Official Transcript of Proceedings
NUCLEAR REGULATORY COMMISSION

Title: Advisory Committee on Reactor Safeguards
 NuScale Subcommittee

Date: Wednesday, March 20, 2019

NuSCALE SUBCOMMITTEE

Figure 9.1.4-1: Refueling Floor Layout

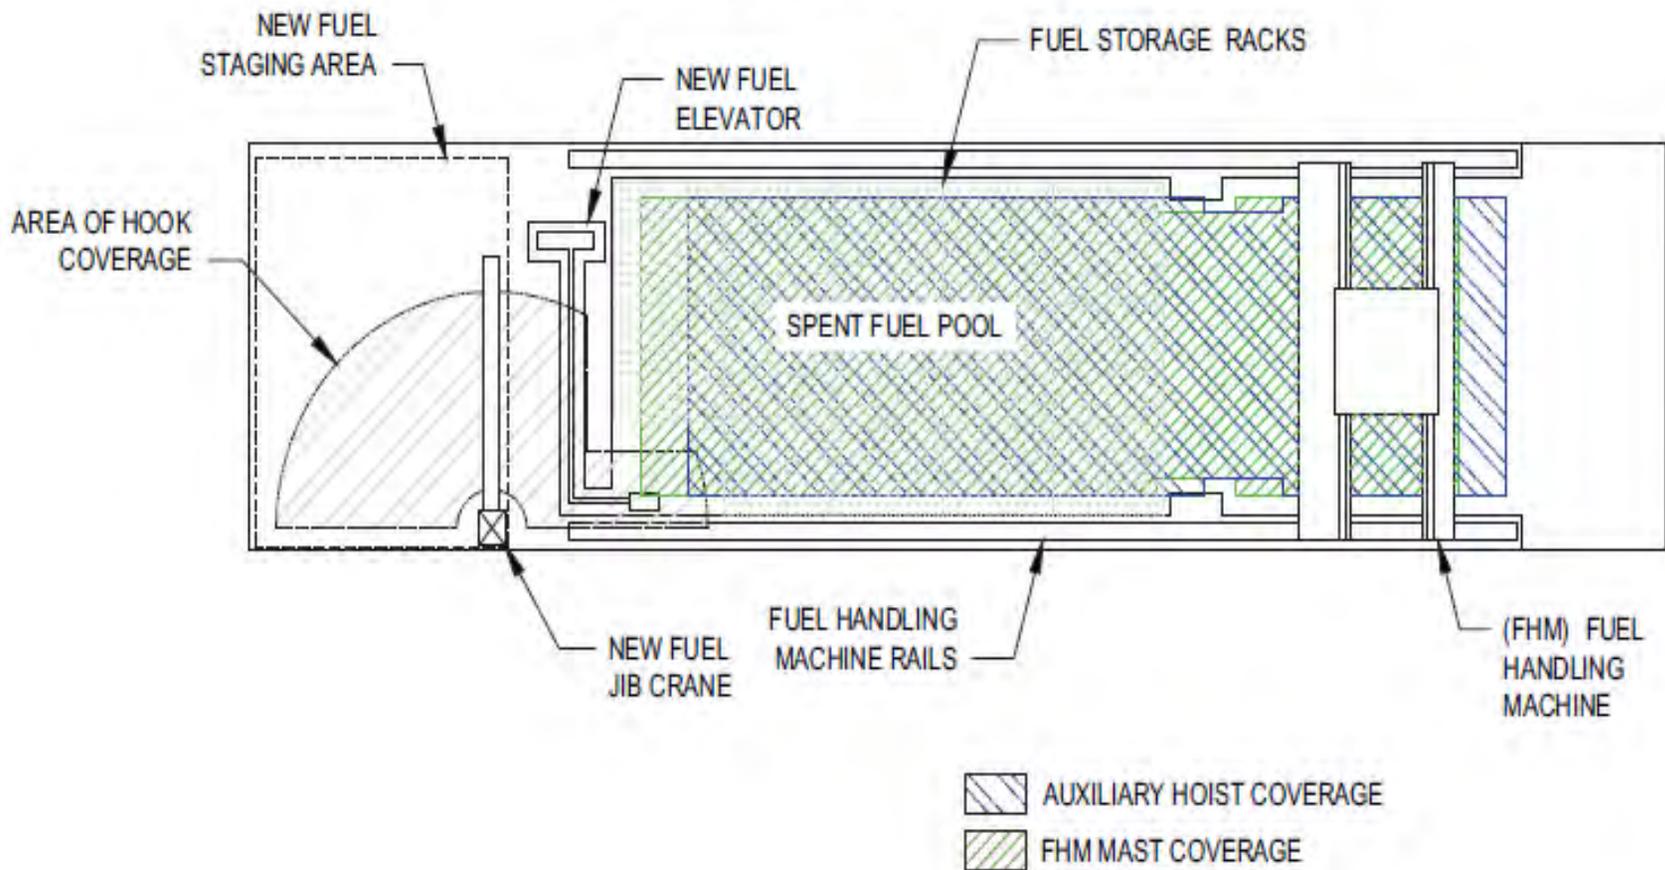
11 So when a module is brought into the
12 plant, it's on its side. It's brought in where the
13 pointer is in the top left of the figure. It's
14 brought in horizontally. It's brought in and then
15 upended in the inspection rack.

9.3.4 - Chemical and Volume Control System (2/3)

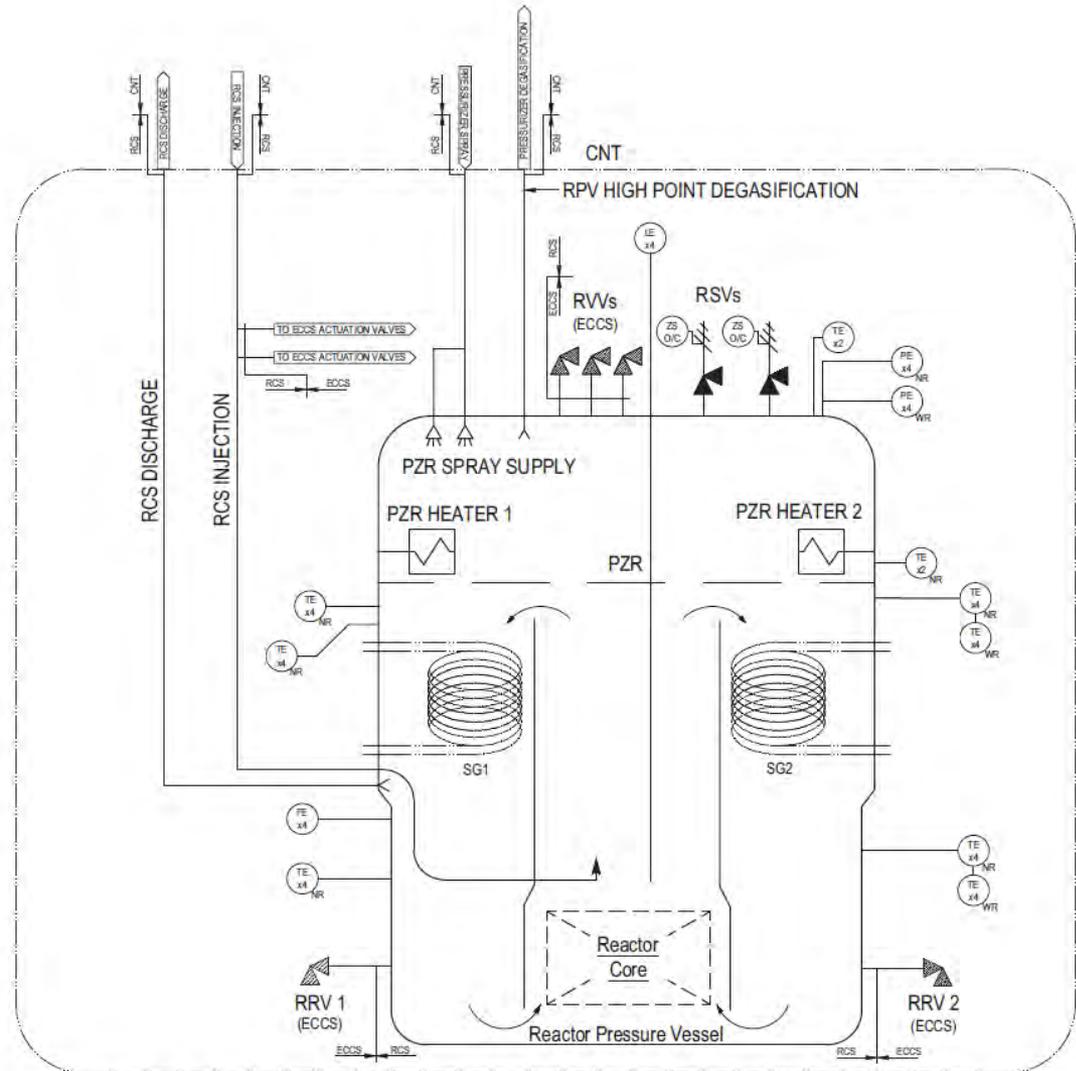
17 I am looking at the design diagram of the
18 CVCS. Which is Figure -- it's on page 9.3. That's
19 84, Figure 9.3.4-1. Which is a diagram of the
20 chemical boron control system.

25 But, it does not show a sampling line on
